The staff confirmatory analysis shows that the APR1400 synthetic acceleration time histories envelop the CSDRS for all specified damping values based on the SRP 3.7.1, Rev. 4, Option 1, Approach 1 criteria. The staff confirmatory analysis also shows that the power spectral density (PSD) functions of these time histories are higher in the frequency range of interest than 70% of the target PSDs developed by the staff, using strong motion durations defined as the duration of near maximum and nearly stationary power of an acceleration time history record. The target PSDs were developed following the SRP 3.7.1 Rev. 4, Appendix B procedure.

## KHNP INPUT

Figure 1 Fourier Spectra for TH in the EW Direction

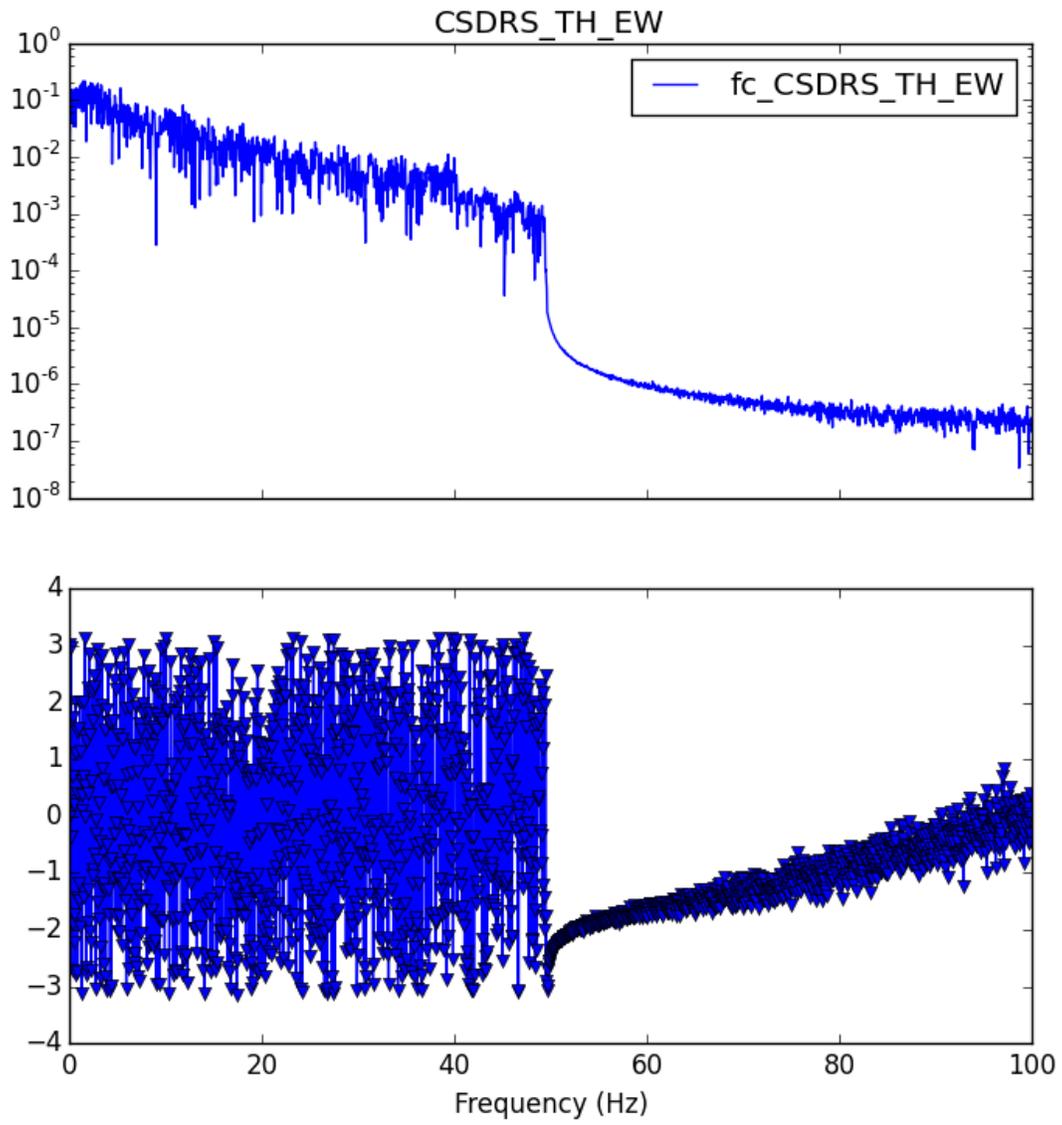
However, the Fourier spectra of the time histories show evidence of low pass filtering with corner frequencies lower than 50 Hz, as shown in the figures below. The issue is more evident in the NS direction, with a corner frequency around 48 Hz. The gaps between the corner frequencies and 50 Hz are small so the effect of filtering out the input motion components between the corner frequency and 50 Hz may not be great. However, an evaluation of this effect can lead to higher confidence in the validity of these time histories. Therefore, the staff requests the applicant to explain why filtering was needed in the development of the synthetic acceleration time histories and develop some justification so that this issue can be discussed during the audit.

In the development of synthetic acceleration time histories to match the APR1400 CSDRS of multiple damping values, a low-pass filter was applied to the time histories because the baseline correction and/or clipping of time history that were performed during the spectrum-matching process introduces artificial high-frequency motion contents in the modified time histories. The upper-frequency value of the low-pass filter near 50 Hz was chosen because 50 Hz was the cut-off frequency of the APR1400 CSDRS. The actual upper-frequency value chosen for the low-pass filter was 48 Hz for the NS component, 49.5 Hz for the EW component, and 48.5 Hz for the vertical component of the synthetic acceleration time history. There was no particular reason for selecting the specific upper-frequency values of the low-pass filter as indicated above. The values chosen produced good results in the response-spectrum matching in the high frequency range near and above 50 Hz. If the above-mentioned low-pass filter was not used, the modified time history generated would have time-history response spectrum values that would not match and converge to the PGA value in the frequency range equal to and higher than 50 Hz.

The response-spectrum-compatible synthetic acceleration time histories generated satisfy the SRP 3.7.1, Rev. 4, Option 1, Approach 1 response-spectrum enveloping criteria for the frequency range from 0.2 to 50 Hz. The power spectral density functions (PSDs) computed from the generated synthetic acceleration time histories envelop, over the frequency range from 0.3 to 50 Hz, the minimum-required (80%) target PSDs compatible with the CSDRS developed following the guidelines and procedures provided in the SRP 3.7.1, Rev. 4, Appendix A, for the low frequency range from 0.3 to 9 Hz and following the time-history simulation method described in NUREG/CR-5347 for the high frequency range from 9 to 50 Hz.

The average PSD which is smoothed over a frequency band width of  $\pm 20$  percent, centered on the frequency, will help to smooth out any PSD gap between 48 Hz to 50 Hz. In addition, due to the band width of the response transfer function of the SDOF system at and near 50 Hz, the spectral response between 48 Hz to 50 Hz shows adequate spectral response amplitude in this frequency range as indicated by the time history response spectra matching the target response spectral values.
